## Product/Process Change Notice (PCN)

PCN #: WE\_HCF\_20171003

Product Affected: WE-HCF sizes 2818

**BEFORE**

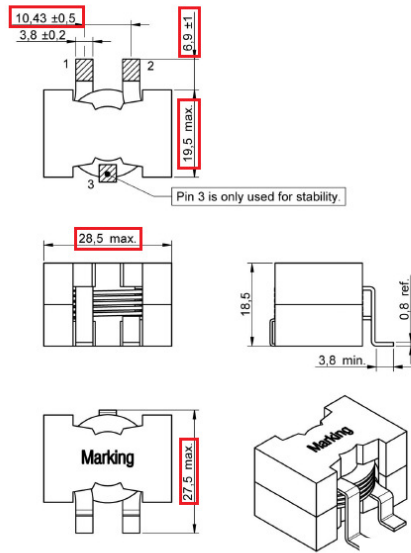
Due to an improvement of the production capability, Würth Elektronik will change some mechanical parameters and associated tolerances. This is related to a partial automation of the production process which leads to an accuracy improvement.

**DETAIL OF CHANGE:**
